Subject: Addendum 2, **Bid FB-26-01, Santa Rosa Technology Magnet Elementary School, Site Piping Replacement, Phase 2 and Quad Renovation Project**

1) Provides the following sheets.

- G1
- G2
- C-1
- CD-1
- CD-2
- Addendum Cover Sheet – Jordan & Bain Landscaping Architects, Inc
- L4.1
- L5.1
- P3.0
- P3.1

Addendum sheets supersede original bid packet sheets and must be used for purpose of providing a bid submission.

L5.1

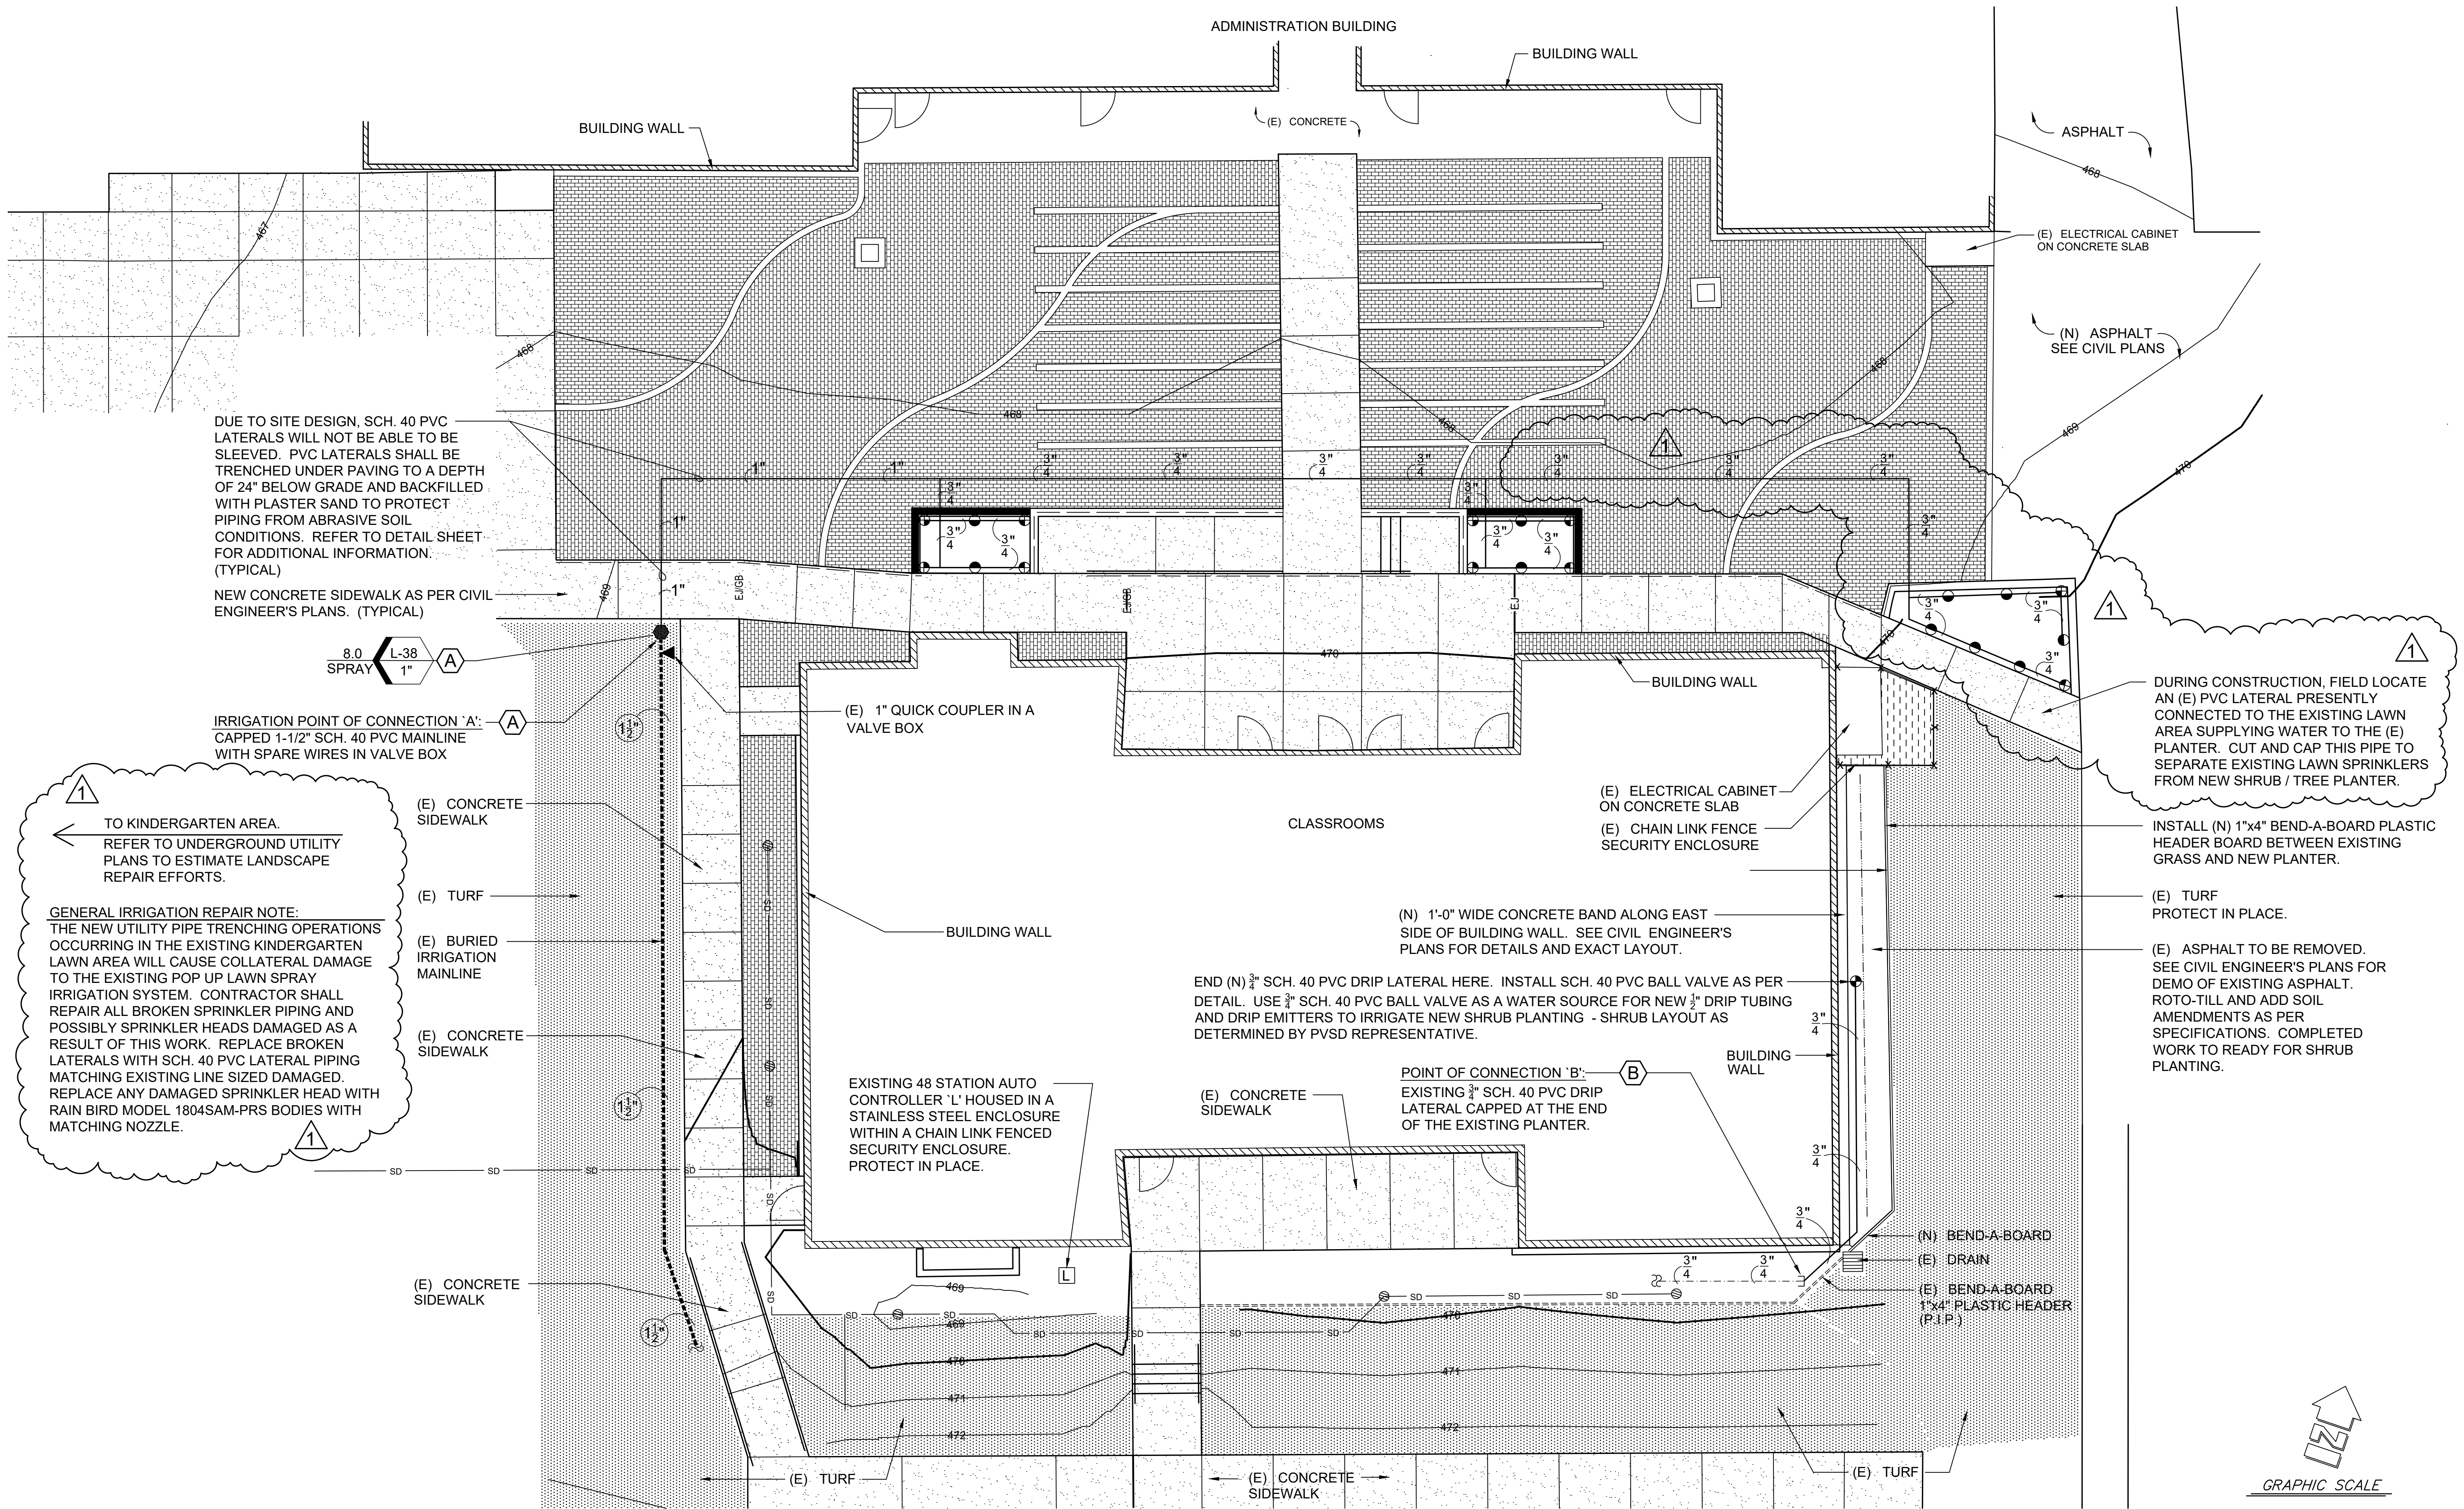
B. Sheet L5.1 – Planting Plan

1. General Planting Repair Note added as follows:

DRAWING
L4.1
SHEET 4 OF 7
PROJECT No. 25.43

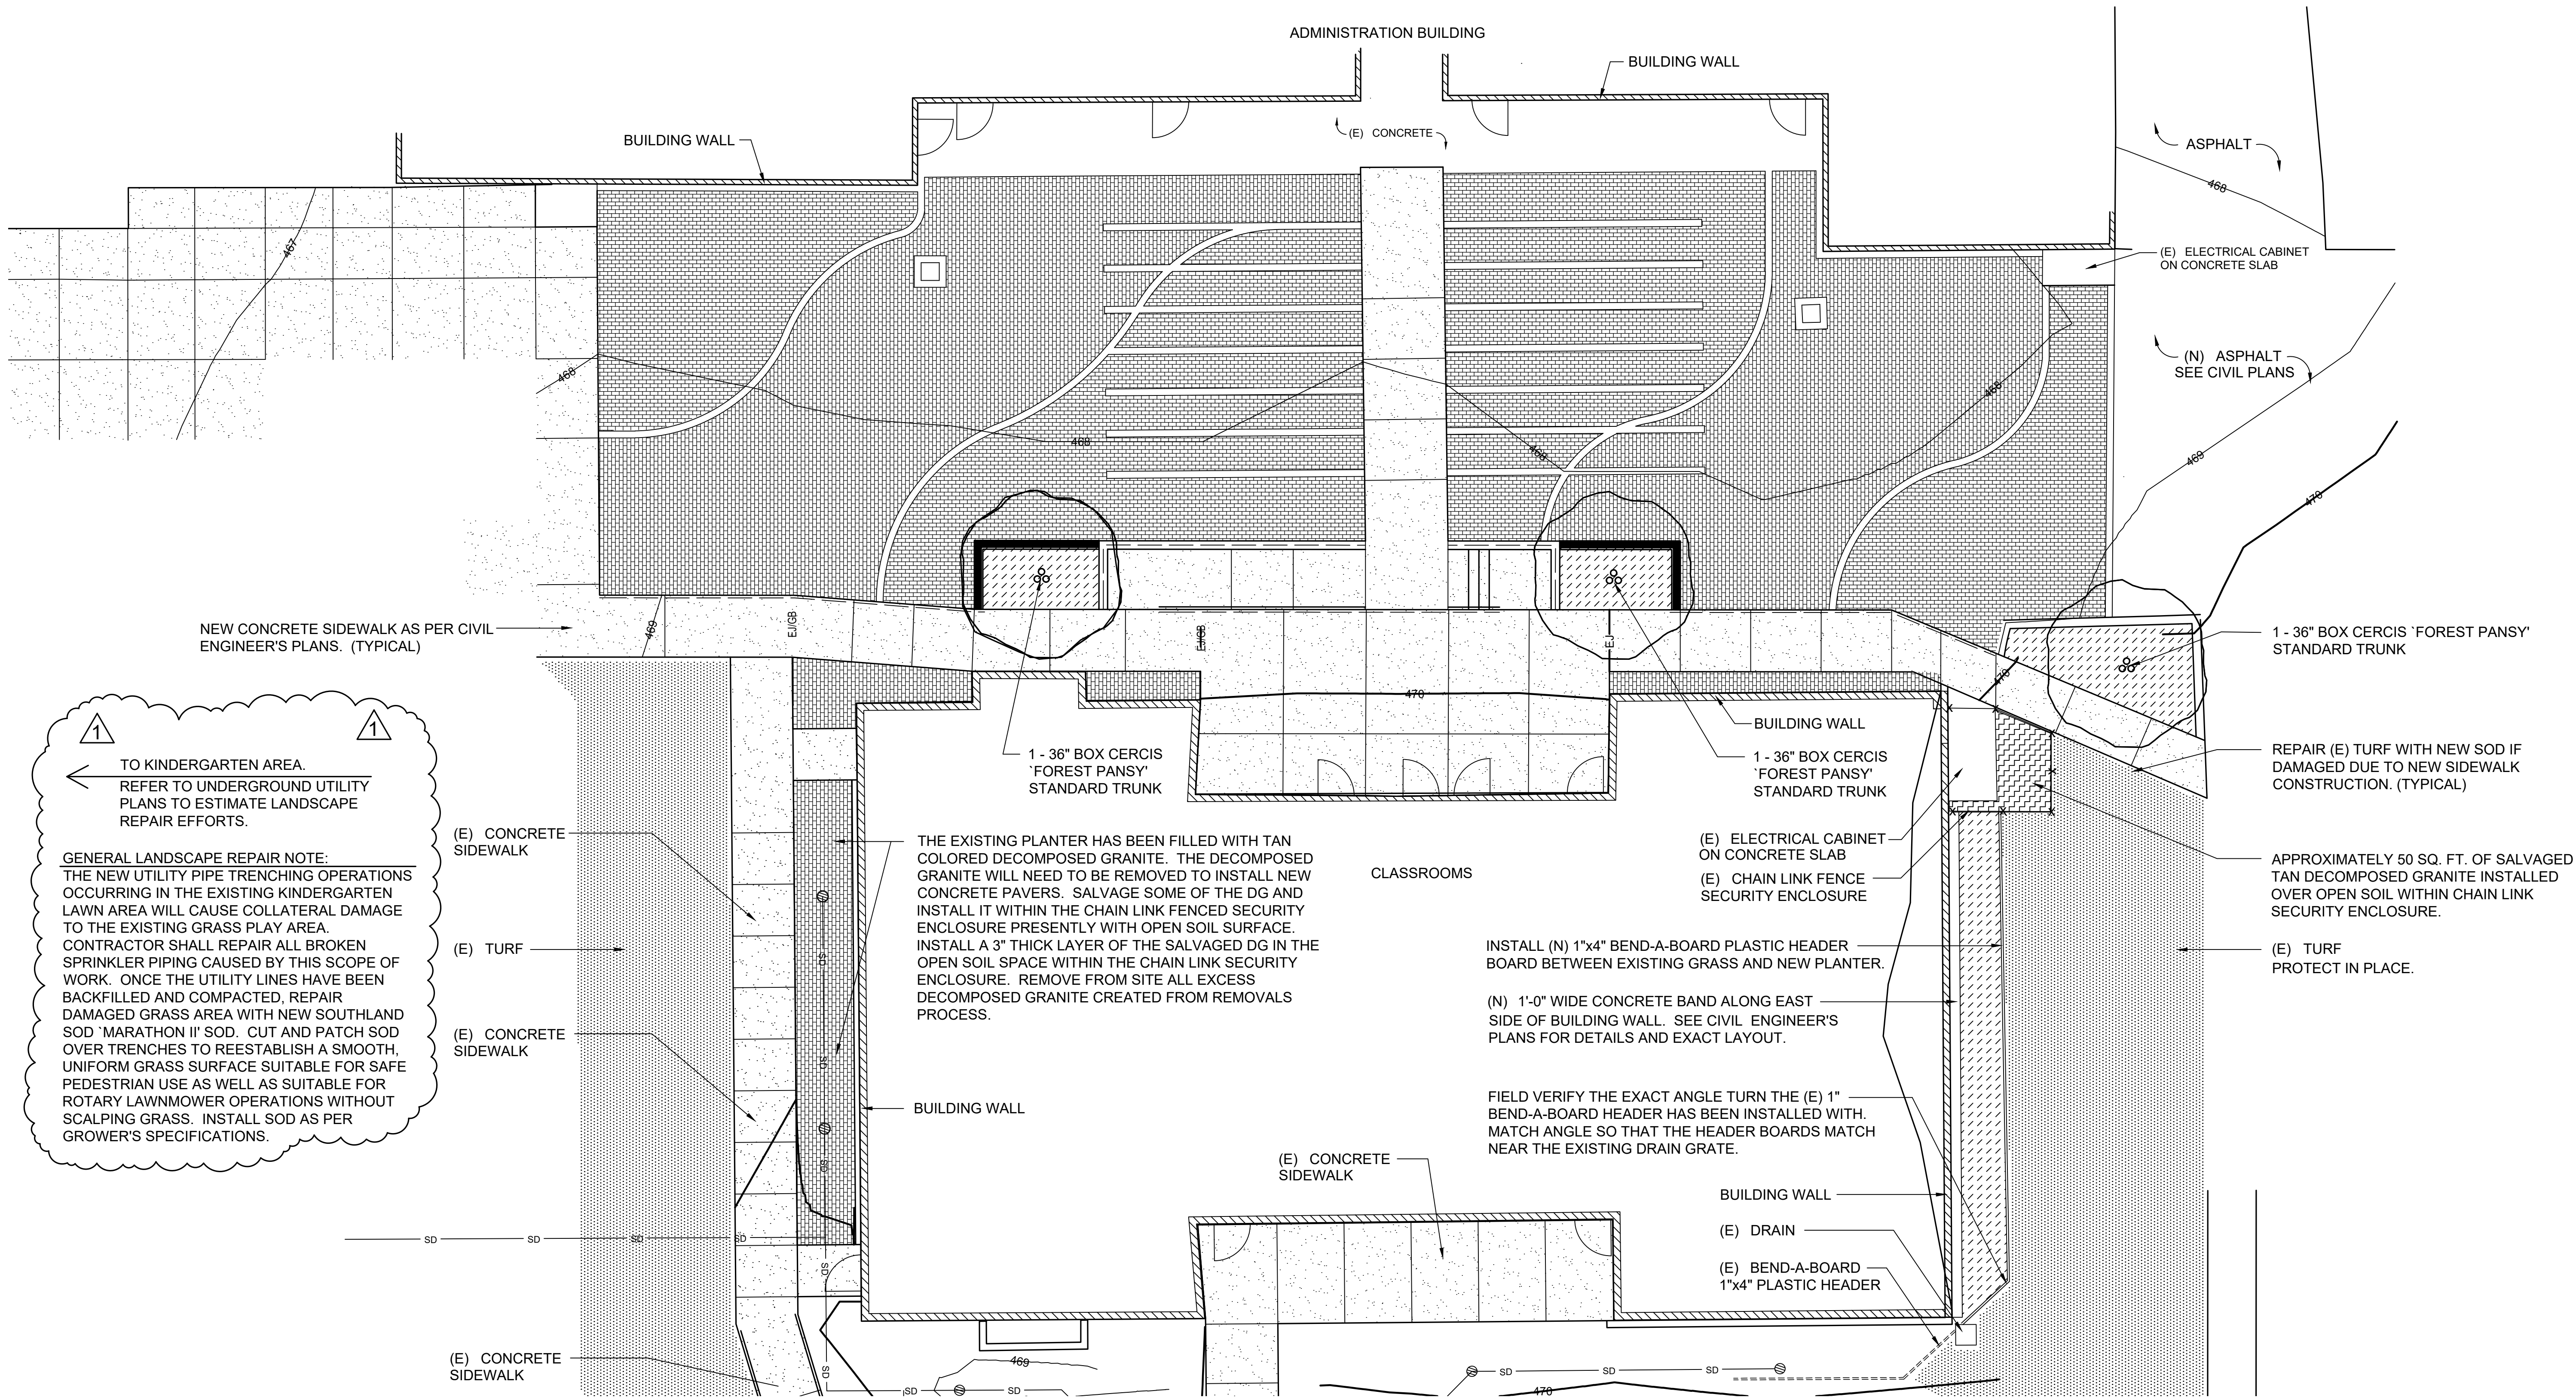
A. Sheet L4.1 – Irrigation Plan

1. Add approximately 100 ln. ft. of $\frac{3}{4}$ " Schedule 40 PVC lateral piping and eight (8) 6" pop-up shrub sprayheads with nozzles to irrigate new shrub/tree planter located near northeast corner of classroom buildings.

2. The existing shrub planter located near the northeast corner of the classroom buildings is currently being irrigated by the adjacent lawn sprinklers. Field verify the exact location of this pipe connection, cut pipe and install line size Schedule 40 PVC solvent weld cap. Completed work will have all new planters irrigated by (N) RCV 'L-38'. The existing lawn sprinklers will not irrigate any shrub planters.

3. General Irrigation Repair Note added as follows:
"The new utility pipe trenching operations occurring in the existing Kindergarten lawn area will cause collateral damage to the existing pop up lawn spray irrigation system. Contractor shall repair all broken sprinkler piping and possibly sprinkler heads damaged as a result of this work. Replace broken laterals with Sch. 40 PVC lateral piping matching existing line sized damaged. Replace any damaged sprinkler head with Rain Bird Model 1804SAM-PRS bodies with matching nozzle."
